MEMORANDUM
DEVELOPMENT SERVICES/BUILDING DEPARTMENT

FROM: PETE JACKSON, ELECTRICAL SPECIALIST

SUBJECT: TARGET ROOF PV FIRE OF 4-5-09
9100 ROSEDALE HWY BAKERSFIELD, CALIFORNIA

Exhibit B

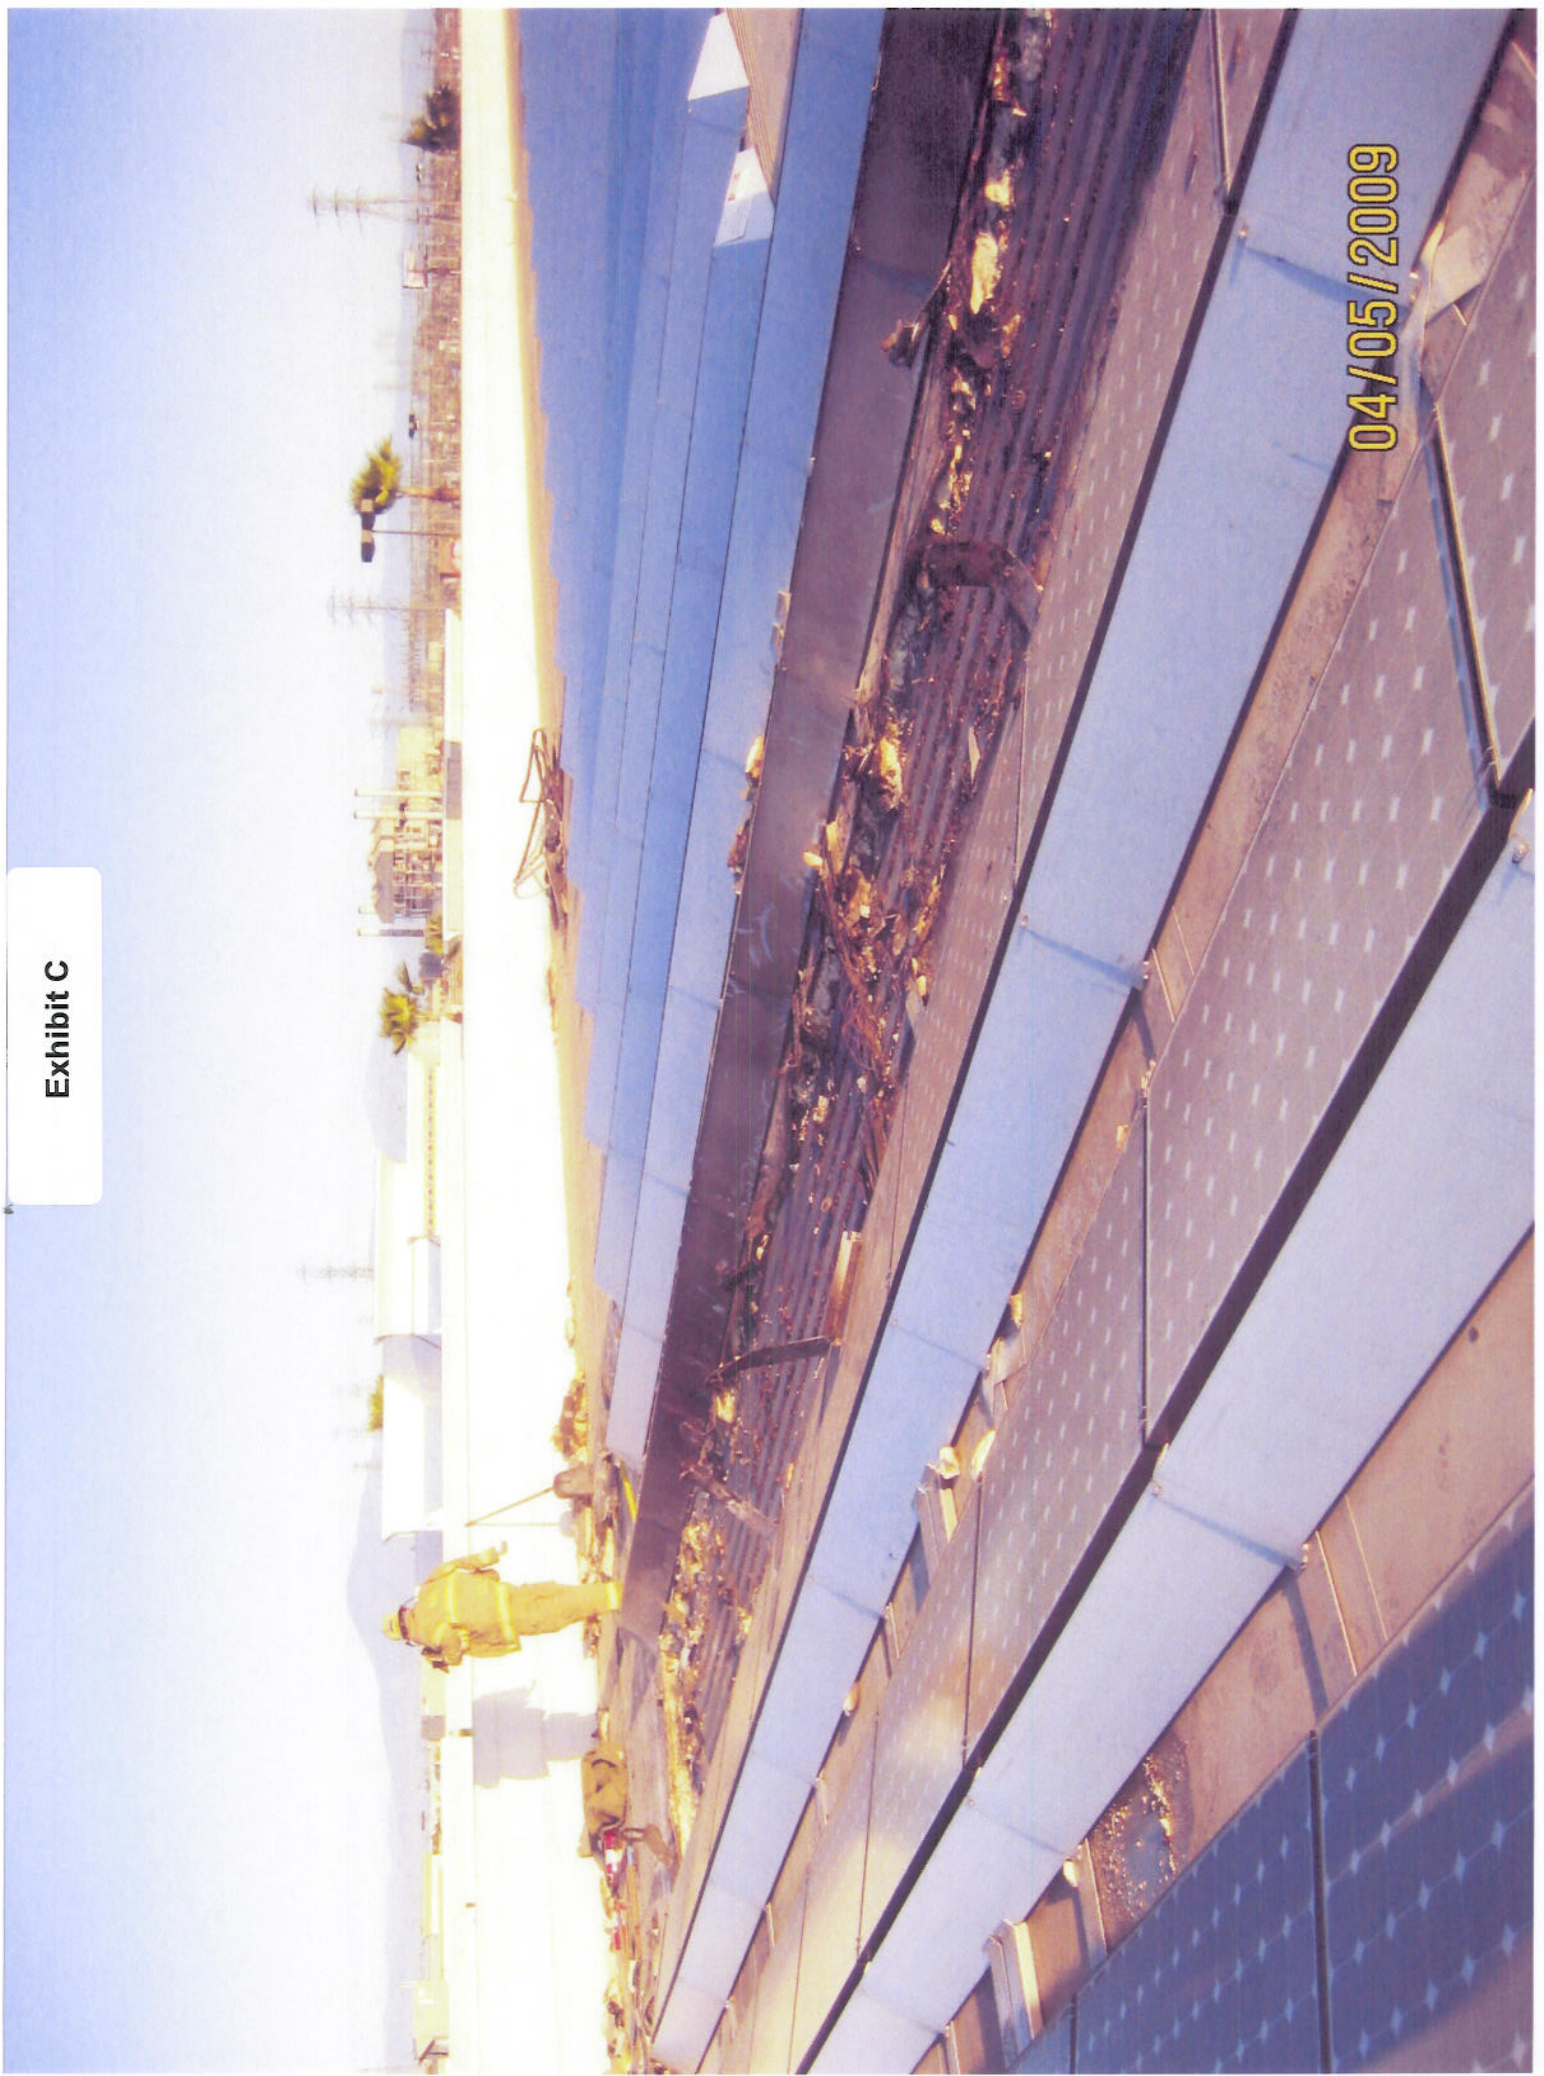
Based on the City of Bakersfield approved plans of 1-29-08, the PV system on the Target store at 9100 Rosedale Hwy consists of 1826 Sunpower SPR-210-WHT photovoltaic modules arranged in 166 strings of 11 modules. The strings are connected to the two Xantrex inverters through four fused combiner boxes (two 30 string, one 50 string and one 56 string). The strings are individually fused with 12 amp fuses. The string short circuit current (Isc) is 5.75 amps and the open circuit voltage (Voc) is 575 Vdc. String operating current is 5.25 amps. String operating voltage is 440 Vdc. **See Exhibits A and B.**

Exhibit D

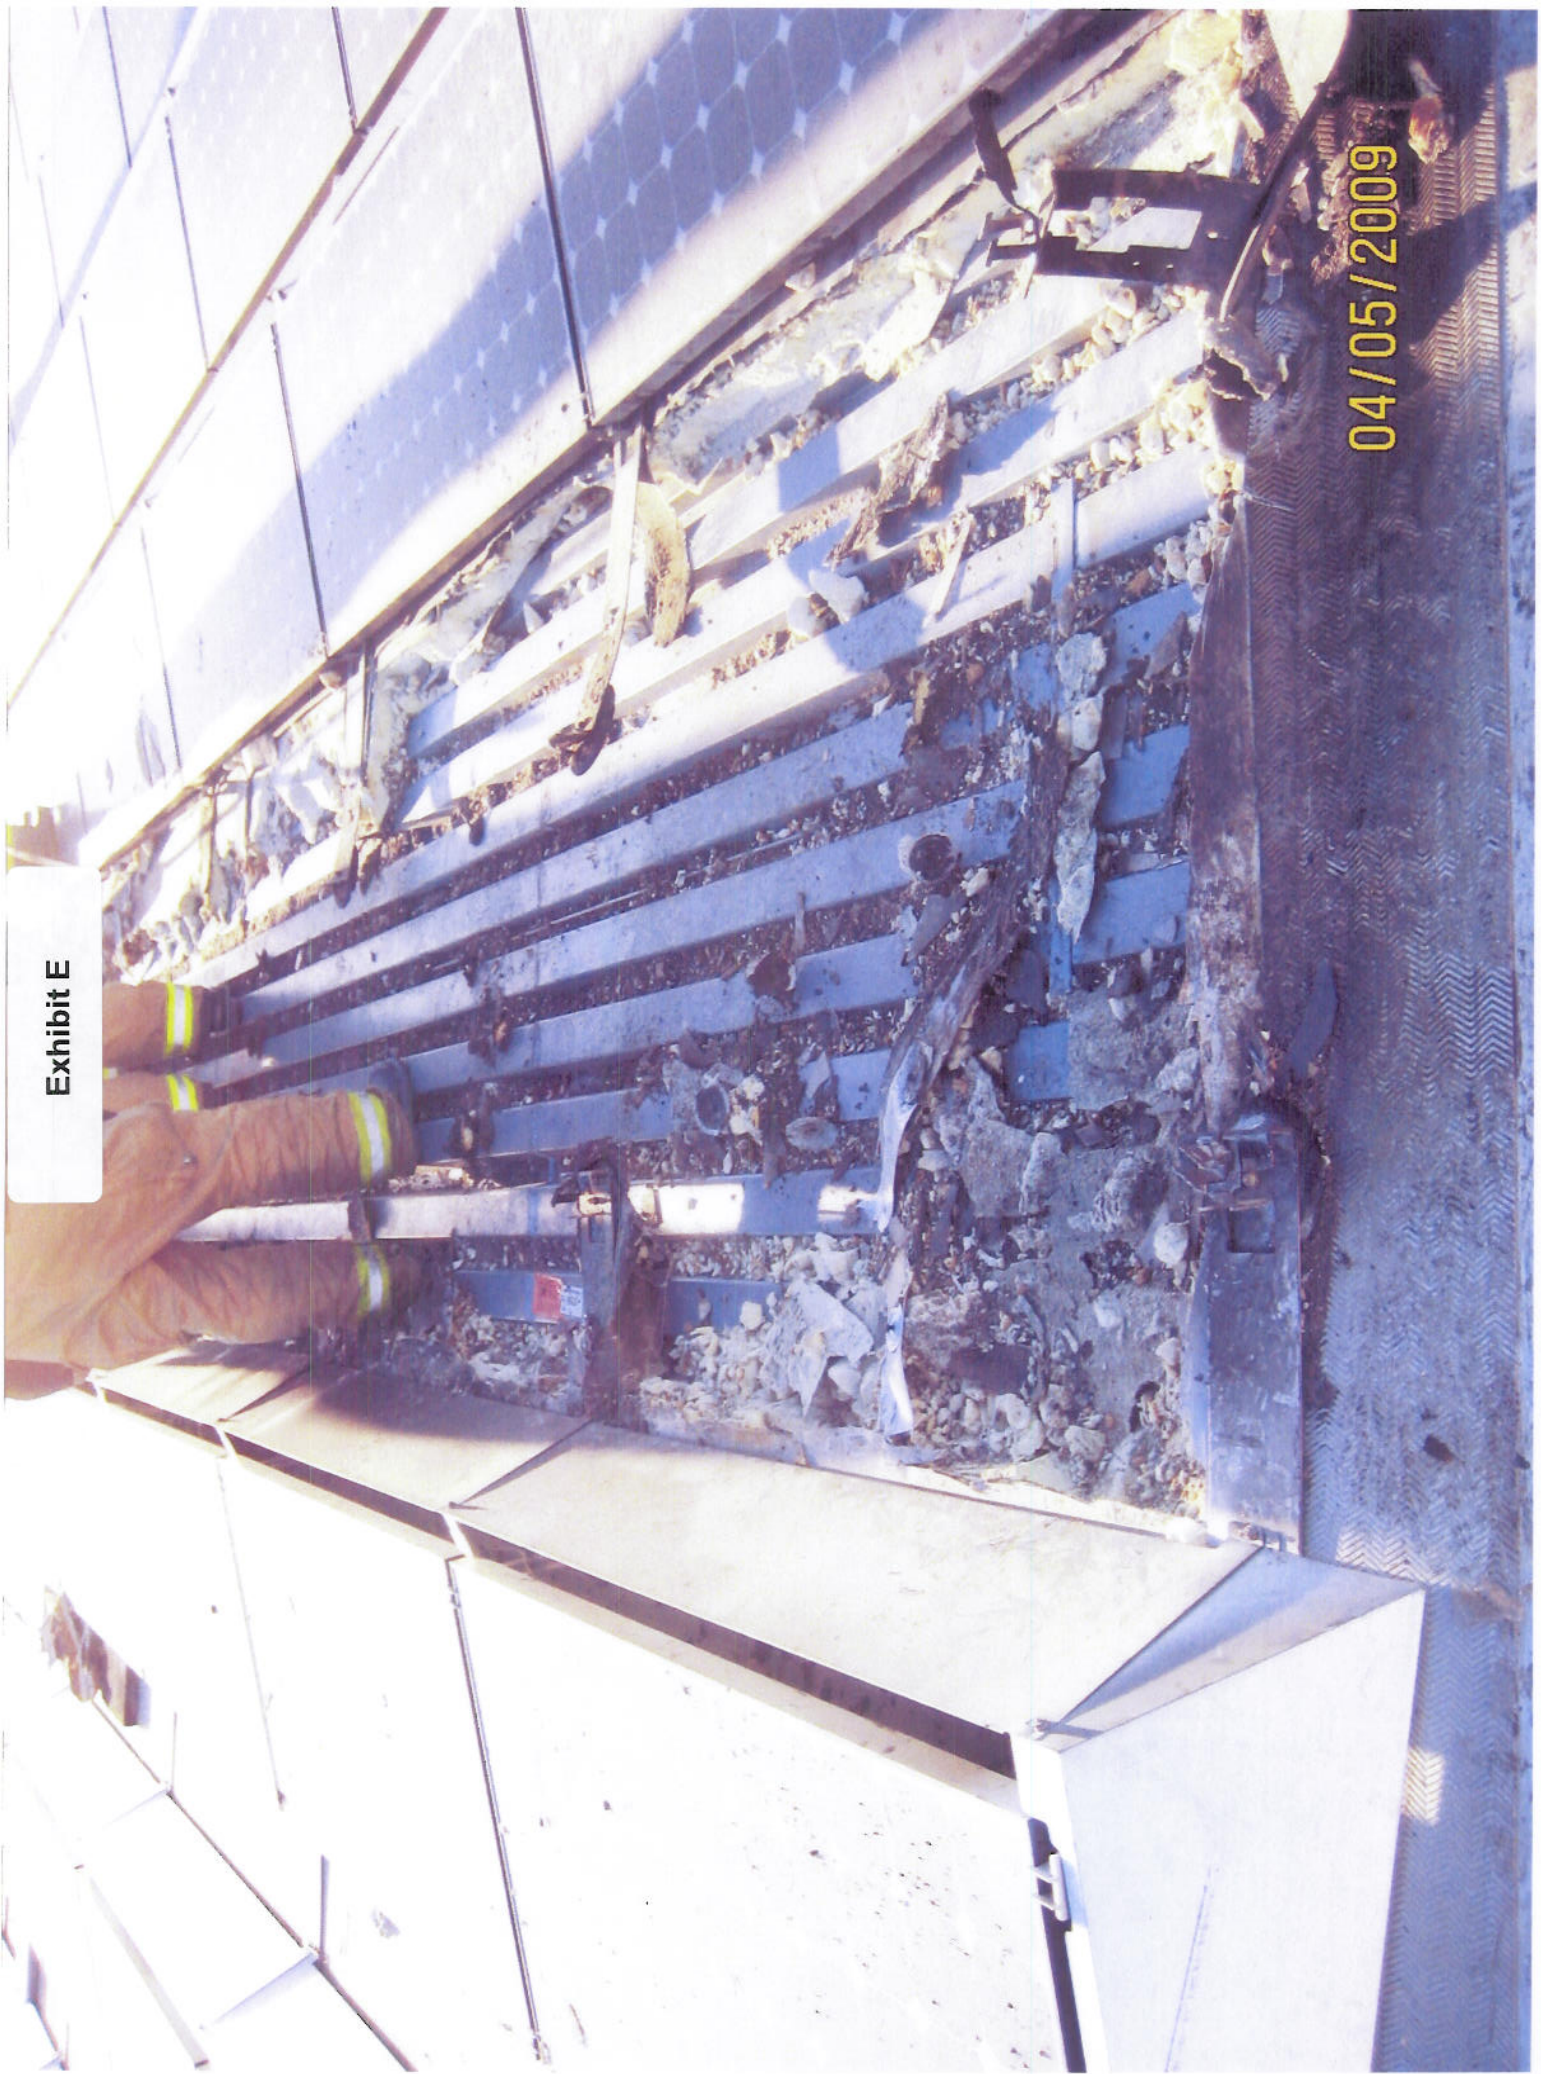
The fire involved modules connected to Combiner Box 1 and the three inch EMT conduit with four #500 KCMIL (two positive and two negative) and a #3/0 AWG equipment grounding conductor which is the output from Combiner Box 1 to the fused DC disconnect for the 225kw (System A) inverter. The smaller inverter (System B) and associated modules were not involved. **See Exhibits C, D, E, F, G and H.**

Exhibit G

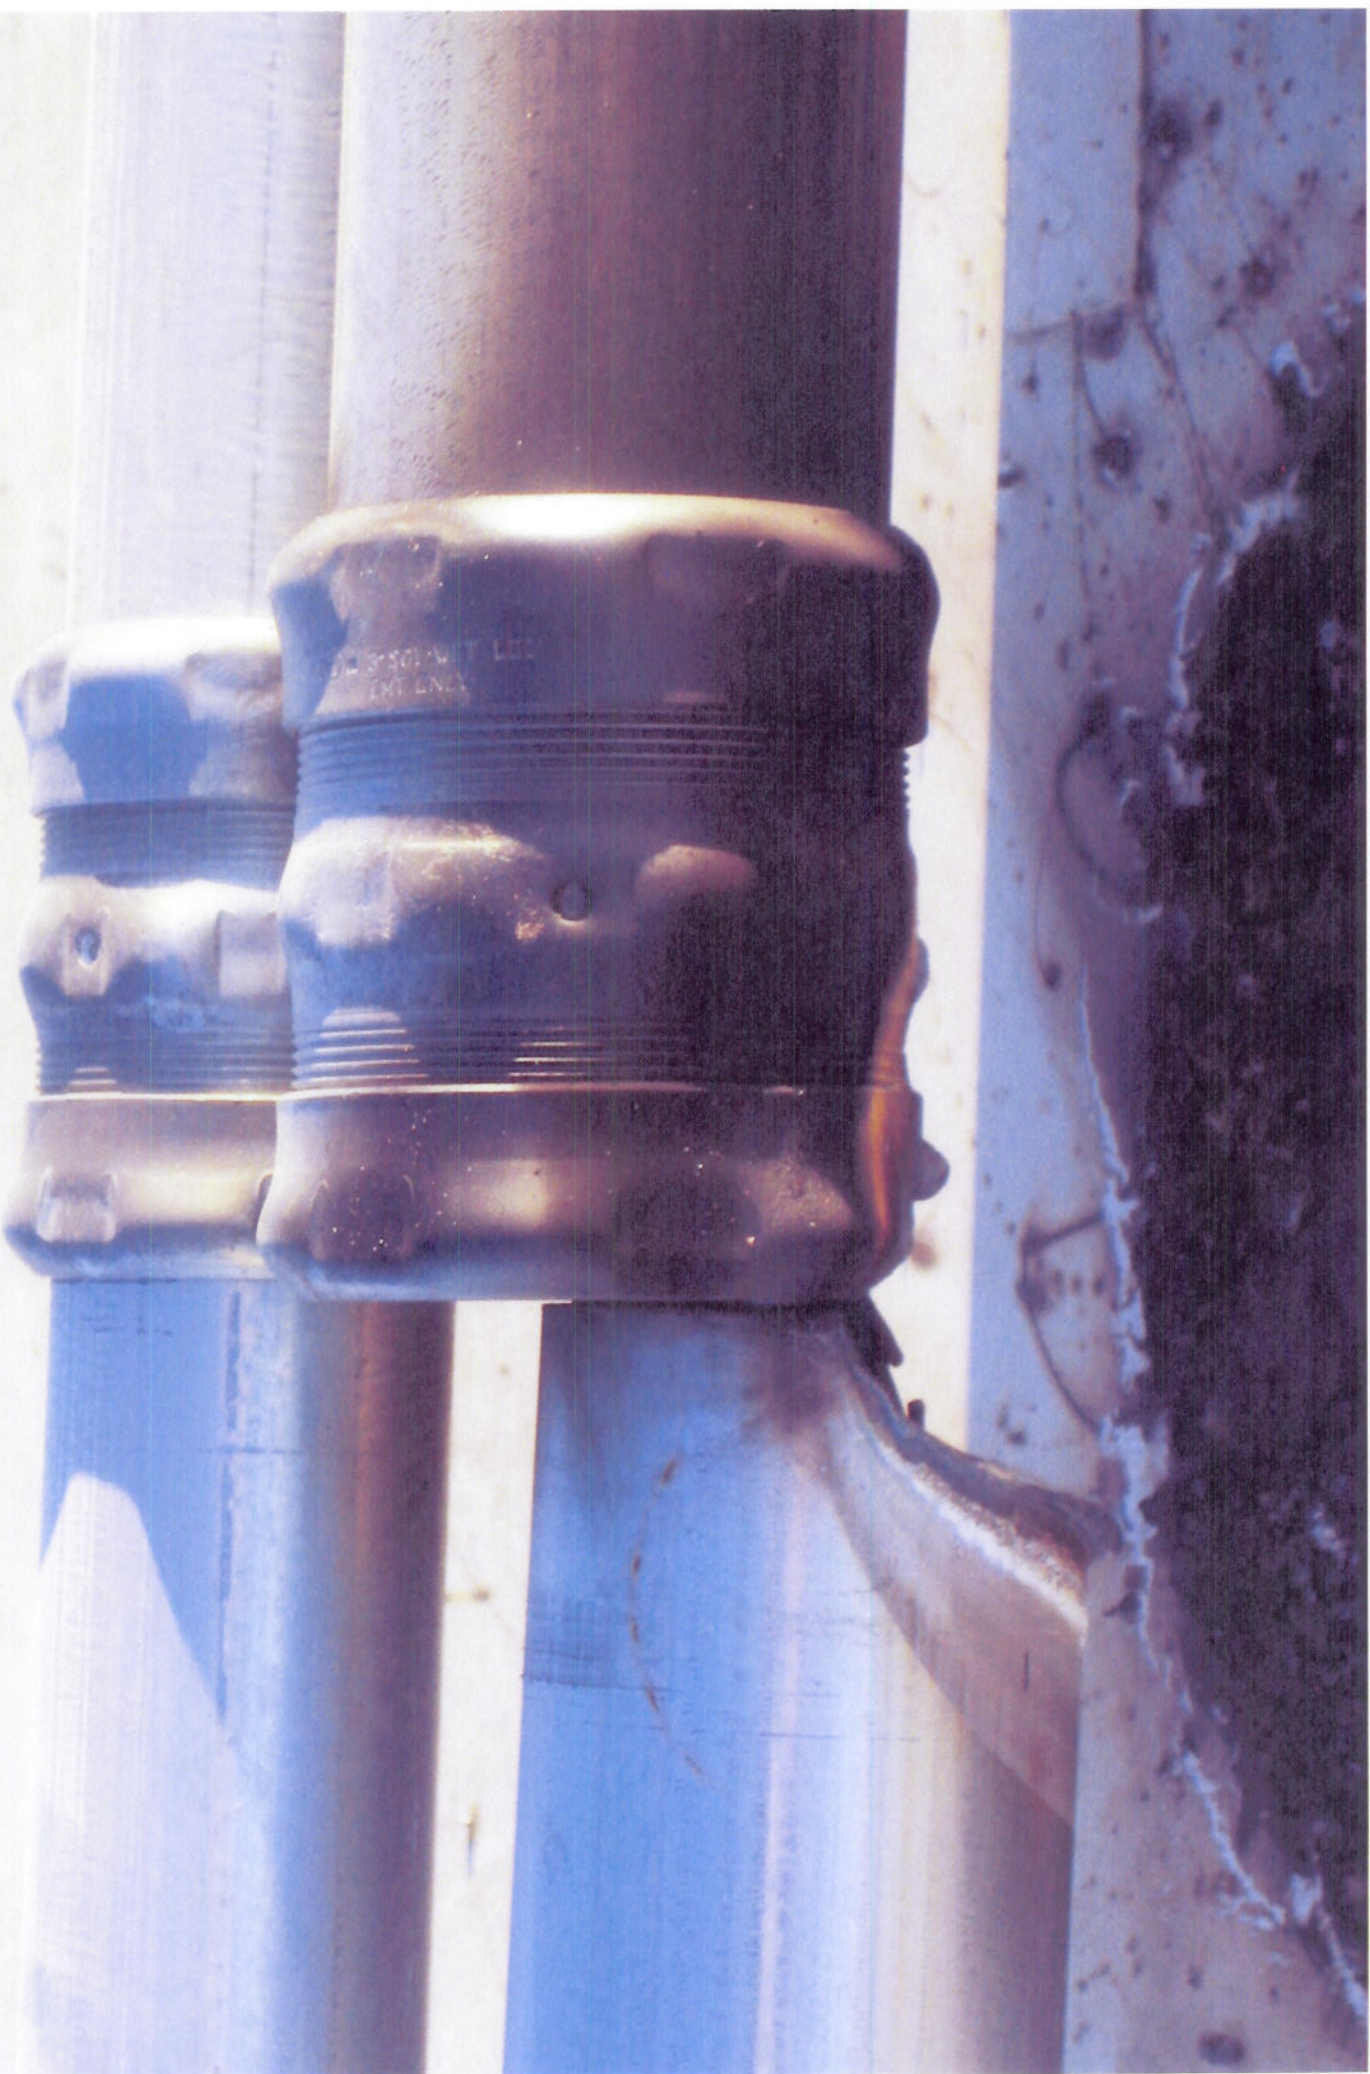
All remaining string voltages were normal (465 – 475 Vdc)
- 3) The equipment grounding lugs in this combiner box (as well as all of the others) are labeled for use with the conductor sizes #500 KCMIL - #4 AWG. The equipment grounding conductor from the combiner box to the PV module is #6 AWG.
- 4) A massive arc occurred in the three inch EMT conduit at a coupling 228' from Combiner Box A1. This conduit contained two #500 KCMIL positive and two #500 KCMIL negative conductors as well as a #3/0 AWG equipment grounding conductor. These paralleled conductors carry the current from Combiner Box A1 to the fused DC disconnect and inverter in the equipment yard. **This conduit is inserted approximately 1/2" into the compression coupling at this point. A complete insertion would require 3". A coupling in the**

conduit next to this one (from another combiner box) was loose (can be turned by hand). All other couplings were checked and were found to be at least "hand tight". **See Exhibits G and H.**

An O-Z GEDNEY AX series expansion coupling was installed 198 feet from Combiner Box A1 (30 feet from the conduit separation). This expansion coupling was not specified to be installed as a part of the design. **This fitting is not listed for use with EMT conduit.** It is intended to be used with RMC or IMC only (threaded conduit systems). The manufacturer produces another fitting for use with EMT. In addition, a mixture of different straps were used to secure the conduit to the UNITSTRUT topped blocks on the roof surface. A total of 24 POWERSTRUT PS1100 STD straps were used which would not allow movement of the conduit on its support blocks. One POWERSTRUT PS 3126 strap and nineteen UNISTRUT P 255830 straps were installed which may have allowed some movement since washers were installed under the clamps to provide annular space around the conduit. A review of the manufacturer's literature for both products did not indicate that the products were intended to be used for applications where movement in the conduit would be needed. **Both B-LINE and UNISTRUT (manufacturers of conduit straps) specify both a one-piece strap which is one pipe size larger than the conduit used or a two piece strap with an insert between the strap and pipe which allows conduit movement in their product catalogs. A B-LINE representative who visited the site confirmed this as well.** The conduits are all supported and secured on the roof by recycled rubber blocks which have a UNISTRUT type of channel for connection of the pipe straps. These blocks are then attached to the roof membrane by strapping (made with the roof material) to the roof itself in accordance with the roofing product standards. These roof support blocks are not designed to slide or move on this roof. If movement is to occur it should occur with the conduit moving on the UNISTRUT topped blocks, not the rubber blocks moving on the PVC roof. **The conduit had an expansion and contraction linear movement of 3.7 inches. The incorrect expansion fitting and straps could cause the movement to occur at one or more of the compression couplings. A loose coupling would very possibly experience the most movement. Conductor insulation damage is a likely result. Conductor insulation damage did occur here. There would be no faults without insulation damage at this point. See Exhibits G, H, L and M.**

- 1) High voltage insulation testing (megger) all of the existing system wiring and any new or repaired wiring per CEC 110.7.
- 2) The conduit systems installed on the roof need to be engineered for the thermal expansion which will occur per CEC (NEC) 300.7 (B) FPN. Expansion fittings and straps listed for the purpose and the conduit system installed must be utilized.
